CONTRACT CHANGE ORDER NO. 1

Old Telegraph Road Bridge Emergency Repairs – Project No: P6X50659

CONTRACT CHANGE ORDER NO. 1**Project Name: Old Telegraph Road Bridge #485 Emergency Repairs**

Exhibit 1

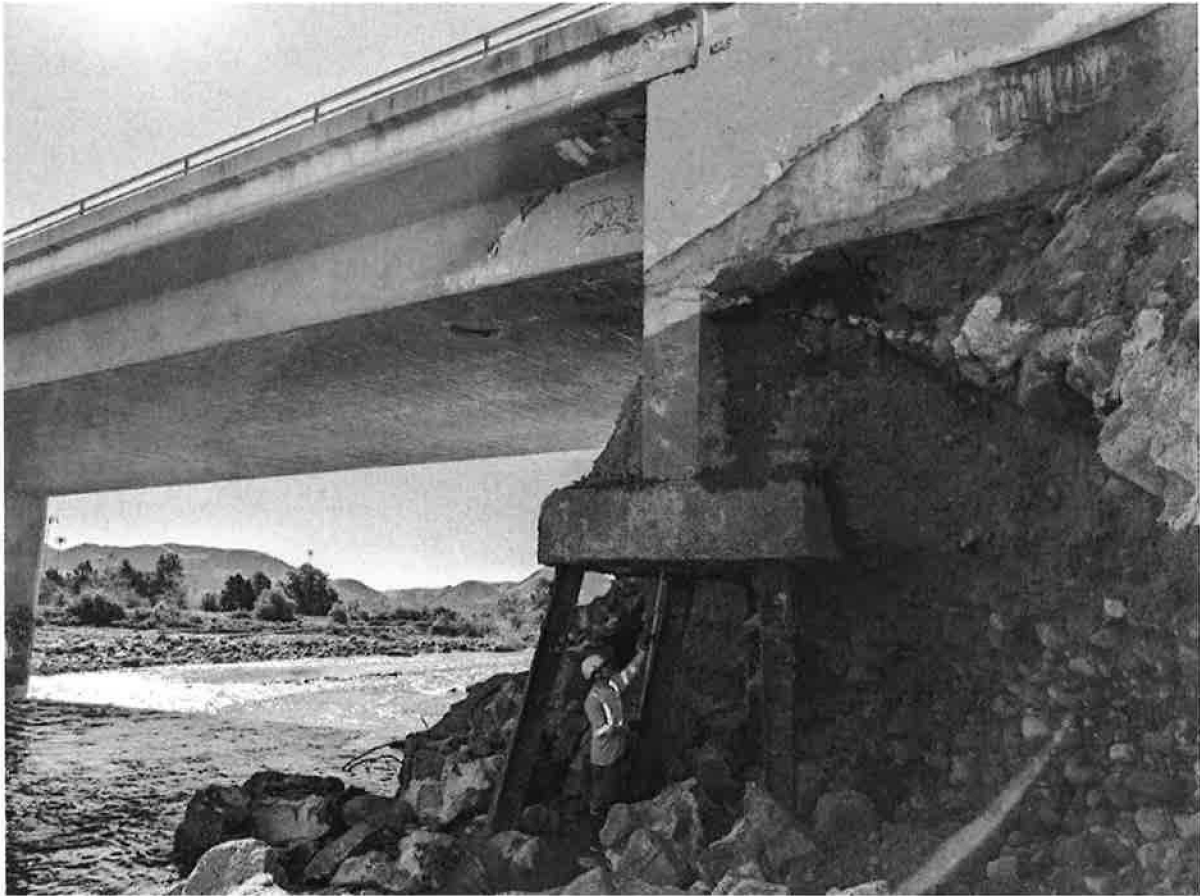
1.1 Add new Contract item, Shotcrete Void Under Wingwall

Prepare cavity under wingwall, install rebar & wire mesh, shotcrete cavity to fill void in Exhibit 1

DRAWN _____ EM	COUNTY OF VENTURA PUBLIC WORKS AGENCY ROADS & TRANSPORTATION DEPARTMENT	RD24-07(E) SPEC. NO.
DESIGNED _____ TH		P6X50659 PROJ. NO.
CHECKED _____	OLD TELEGRAPH ROAD BRIDGE #485 EMERGENCY REPAIRS	SHEET 1R
APPROVED _____

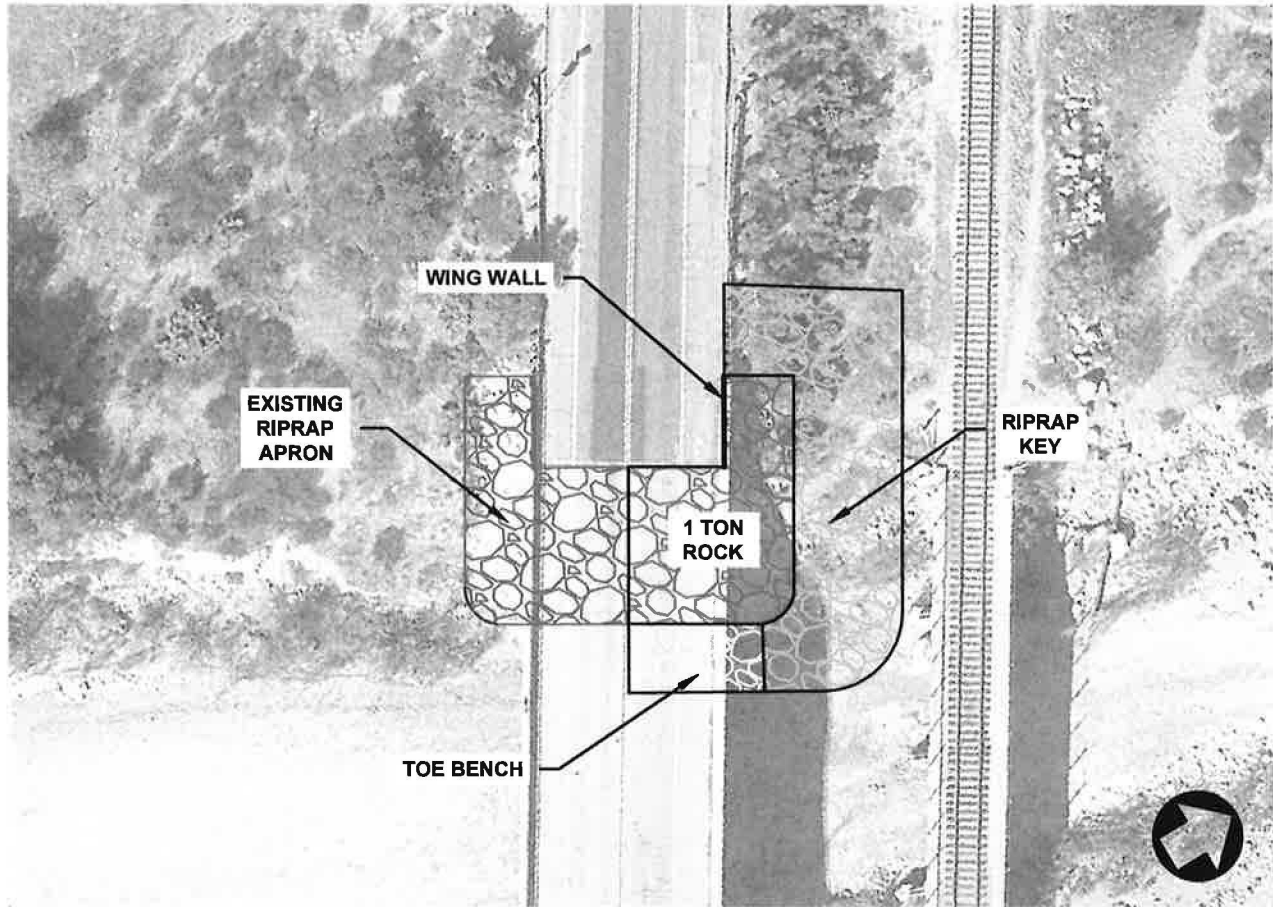
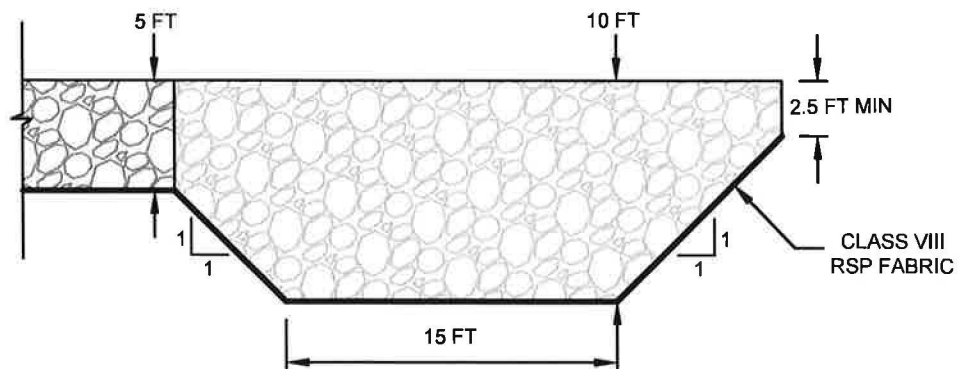
1.2 Add new Contract item, Place Class II Base under riprap Per Exhibit 2

1.3 Add new Contract item, Place Filter Fabric under riprap Per Exhibit 2

1.5 Add new Contract item, Riprap toe bench on upstream side of abutment

Replace Sheet 1 of the plans with Sheet 1R per Exhibit 2

CONSTRUCT KEY ON UPSTREAM SIDE OF CLASS VIII RIPRAP ON APPROACH SLOPE & OVBANK OUTSIDE THE AREA SUPPORTED BY THE "TOE BENCH".
